**WARRANTY
BULLETIN**

Wb04-05C

DATE : MARCH 2006	SECTION : 05 - Cooling
EXPIRATION: MARCH 2008	
SUBJECT : REPLACEMENT OF THE BELT TENSIONER BELLOWS ATTACHMENT BRACKETS

REVISION : C

FIGURE 1: PRESSURE RELEASING VALVE H3 & VIP

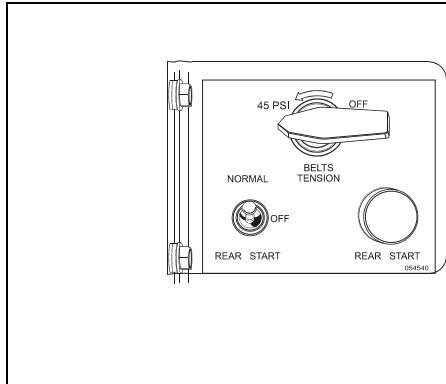
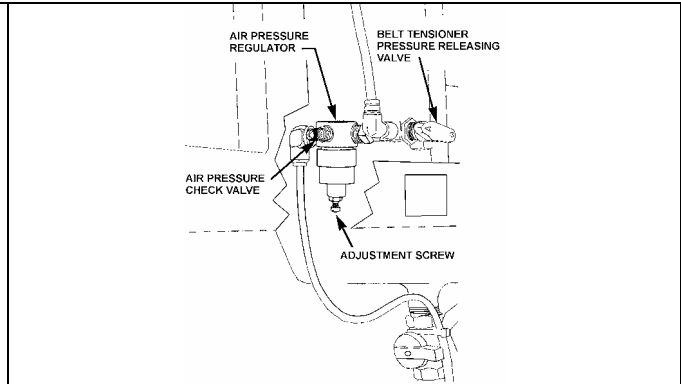
1. Inside the engine compartment, release pressure from the air bellows by turning the belt tensioning pressure control valve handle to OFF (figure 1 & 2).
2. Disconnect the air lines and fittings from the bellows (figure 5 & 6).
3. Dismount the attachment brackets and bellows.
4. Check if the air bellows and belts were damaged as shown in figure 3, replace as needed.

FIGURE 4 : MOUNTING HOLES

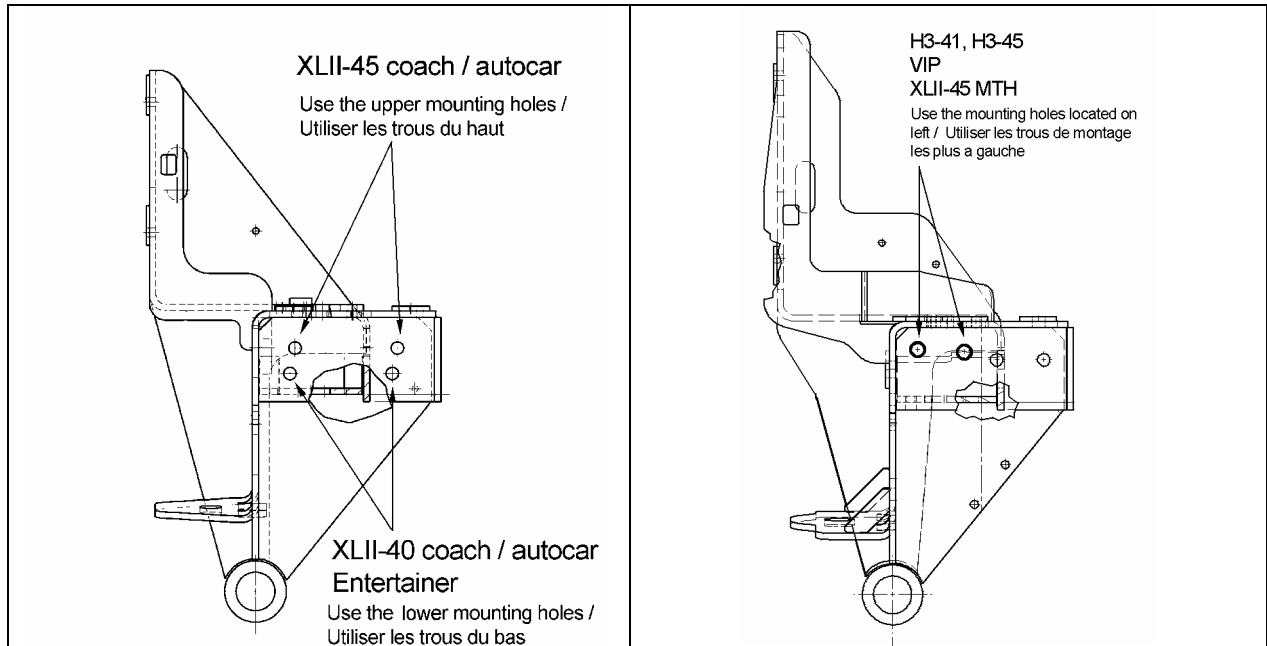
5. Reinstall the bellows with the new attachment brackets. For mounting of the gearbox side attachment bracket, use the mounting holes indicated on figure 4. Tighten bolts as specified in figure 5 & 6.
6. Reinstall the fittings and connect the air hose. Use Teflon tape on threads.

FIGURE 7: GAP MEASUREMENT

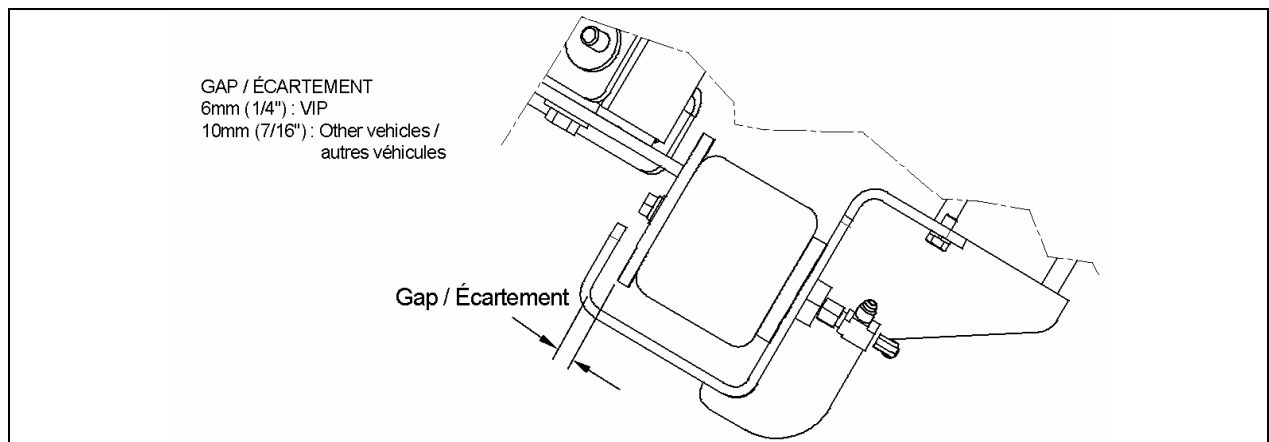
7. Reapply the air pressure to the bellows. Check if the gap (see figure 7) between the stop and the plate at the top of the bellows is as specified.
8. If the gap is not as specified, release pressure from the bellows. Loosen the bolts on the gearbox side attachment bracket, adjust the position of the attachment bracket and then tighten the bolts. Reapply the air pressure and check the gap once again. Correct as necessary.
